**NOTICE OF DECISION**  
**Fairfield by Marriott Inn & Suites – 900 Block N Brutscher Street**  
**Design Review/Variance – DR222-0001/VAR22-0002**

Fairfield by Marriott Inn & Suites - Design Review/Variance – DR222-0001/VAR22-0002

REQUEST: Development of a 79-room hotel

DATE	2-28-2020
SCALE	NOTED
DRAWN	CHECKED
MPL	EH
SHEET NO	<b>L1.0</b> 1 OF 2

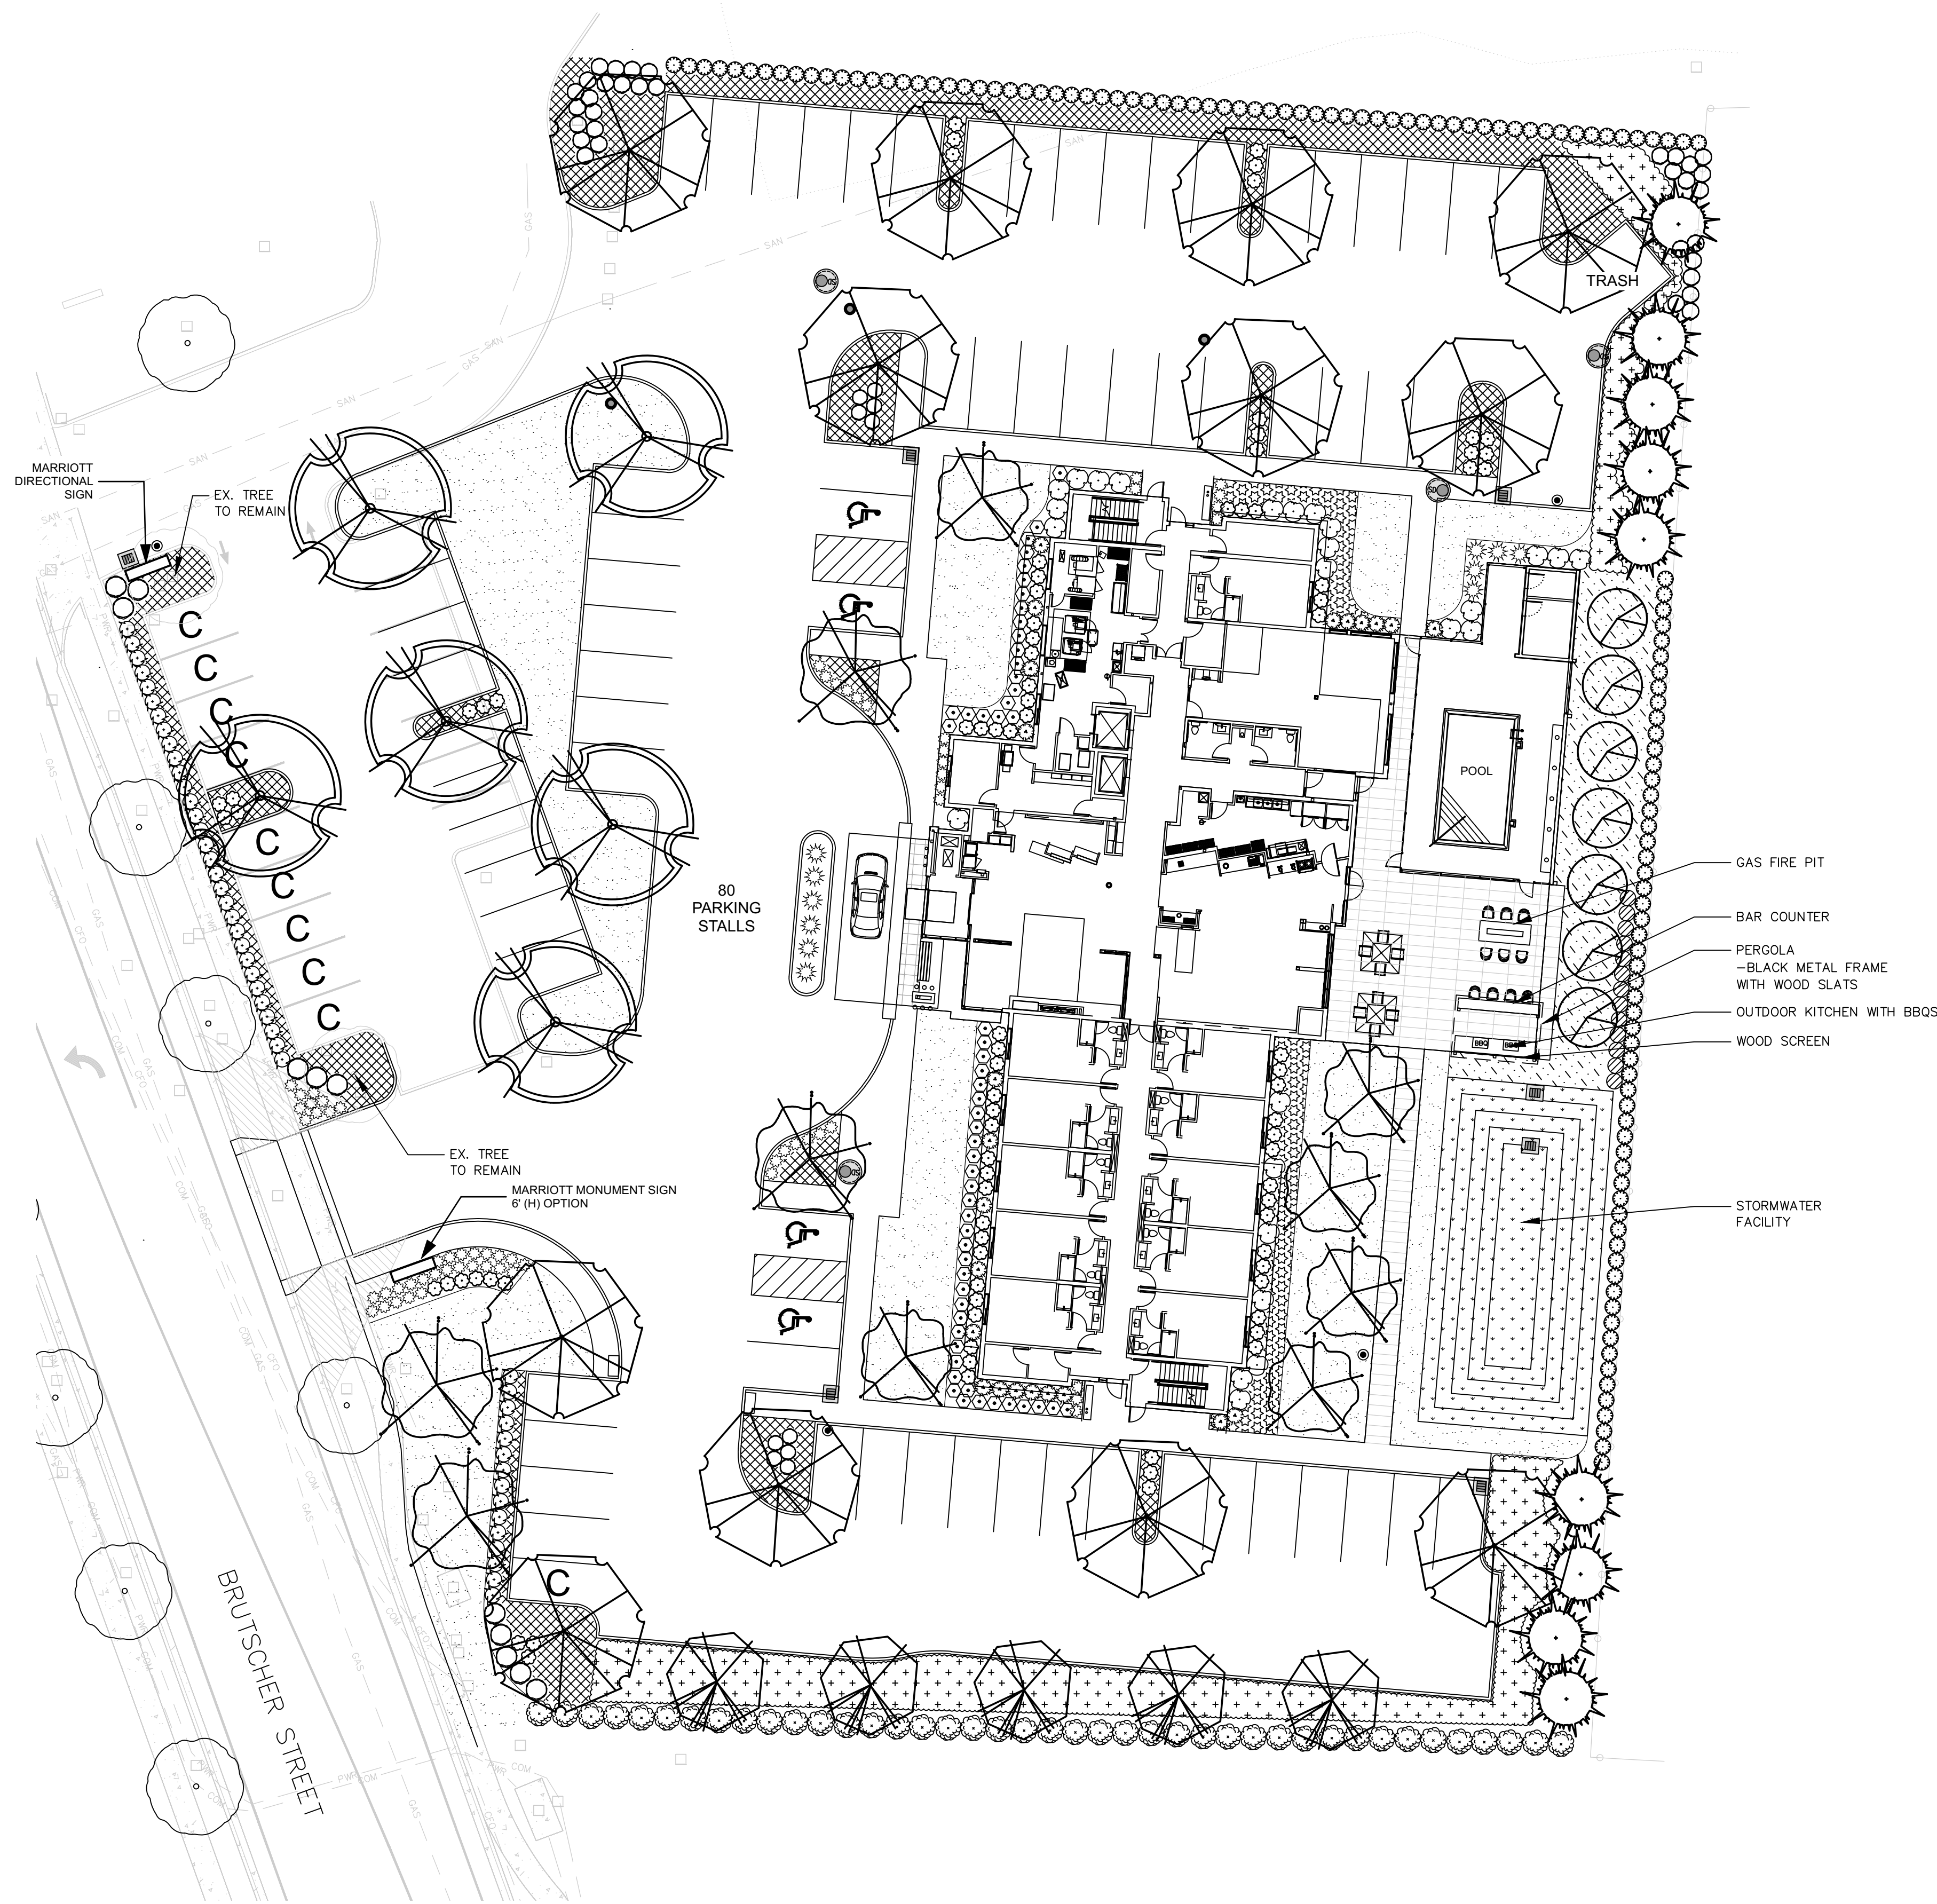
**Finding:** The Landscape Plan Sheet L1.0 indicates a trash area at the northeast corner of the site. No details on the trash enclosure have been provided to comply with NMC 15.220.030(12). Because no information has been submitted the requirement is not met. The applicant shall provide details for a trash enclosure in conformance with NMC 15.220.030(12) Trash and Refuse Storage. All trash or refuse storage areas, along with appropriate screening, shall be indicated on the plans. Refuse storage areas must be constructed of brick, concrete block or other similar products as approved by the director at the time of Building Permit submittal.

**Finding:** Landscaping proposed on the Landscape Plan Sheet L1.0 identifies a combination of groundcover, shrubs and trees (deciduous and evergreen) along the interior property lines and exceeds the minimum of two different plant material groups and meets the criterion.

**Finding:** The Landscape Plan Sheet L1.0 indicates that the parking areas are broken up with landscape islands so that no more than seven parking spaces in a row occur. Each of the landscape islands has an identified deciduous tree. The landscape island on the north side of the site is located within a public wastewater easement. Trees are not permitted to be planted within a public wastewater easement. The applicant shall modify the landscape plan to not show parking lot shade trees in the public wastewater easement.

- the proposed bicycle parking as part of the Building Permit submittal.
- b. The Landscape Plan Sheet L1.0 shall be revised so that it is kept free of all visual obstructions from two and one-half feet to nine feet above the curb line and submitted as part of the Building Permit plan submittal.
